AGENDA
2013 Fish Passage Plan Change Form Review
January 24, 2013 (0900-1530)
CRITFC, Columbia Room

FPP Change Request Form

Change Request Number & Title: 13LWG002 - Table LWG-5 Unit Priority

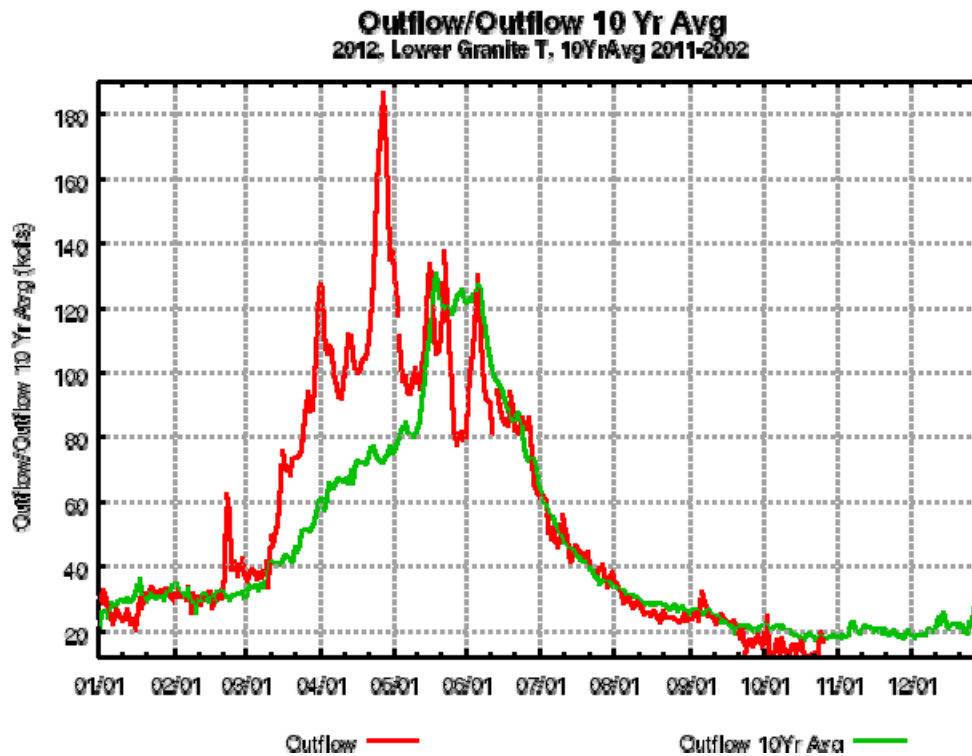
Season	Duration	Unit Priority
March 1 – December 15 (except during 2013 Test Periods below)	Start Units - 24 hours/day	2, 3, then 4-6 any order, then 1 ⁱ
	Stop Units - 24 hours/day	4-6 any order, then 3, 2, 1 ⁱ Stop Units in reverse Start Unit order, except run Unit 1 as long
April 13 – June 30 During 2013 Test Periodsⁱⁱ	Start Units - 24 hours/day	2, 5, 6, 3, 4, then 1
	Stop Units - 24 hours/day	4, 3, 1, 5 or 6, then 2
December 16 – February 28	24 hours/day	Any Order

i. Unit 1 has fixed Kaplan blades and can only run at 130 megawatts. The Unit Priority order in Table LWG-5 minimizes starts and stops of Unit 1 and allows for the longest runtime once Unit 1 is started.

ii. In 2013, modifications to turbine unit priorities are only needed during testing of the prototype overflow weirs and enlarged 14” orifices. Unit priority operations during the test period are currently anticipated to be 24 hours per day, 6 days per week. Implementation of final study plans will be coordinated with RCC and Lower Granite Dam project staff.

Prototype overflow weirs and enlarged 14” orifices are being installed into intake gatewells 5A and 6A during the winter of 2012/13 and are expected to be ready for biological testing during the 2013 fish passage season. Biological testing will be conducted from 13 April 2013 through 30 June 2013 to coincide with peak fish migration periods and accommodate cavitation repairs to turbine units 5 and 6. Final study plans during the test period are still being developed and will be coordinated with RCC and Lower Granite project staff for implementation. In order to conduct the necessary biological testing, deviations from the standard turbine priorities (Figure 1) will be necessary to operate Units 5 and 6 during the testing periods (Figure 2).
